#### Cathy McGrath

The Permit includes TSF-1 and TSF-2 and addresses dust mitigation from those two tailings piles (to the top of the "F")

# FIGURE 18-2: INFRASTRUCTURE ARRANGEMENTS

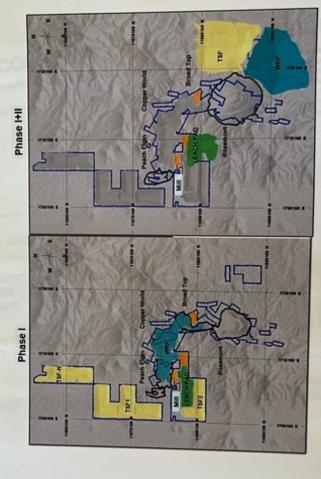
Yet, there is a third tailings area, TSF-N, which will be necessary to store tailings generated over the proposed life of the mine. TSF-N is listed in their 2022 PEA and their 2023 PSF. It is not included in the Permit, as Hudbay has not acquired the state land needed to connect them to TSF-N on their private land north of the two current storage areas.

This Permit should not be granted for the life of the mine, as it fails to contain enough storage for the amount of tailings that will be excavated from the 6 pits over the life of the mine.

If Hudbay is ever successful in acquiring the 160 acre state parcel, a significant amendment to the Permit will be required in order to add in TSF-N. This storage area is by far the most devastating to the community 1/2 mile north of its location. There are many ephemeral washes in the area, high wind and rain events are prevalent during monsoon season. Monitoring stations will need to be relocated, public comment will need to be re-initiated and there is no guarantee that TSF-N will be added into the Permit. Therefore, it is premature to grant a Permit for the proposed life of this mine, without all necessary facilities included in the current Permit.
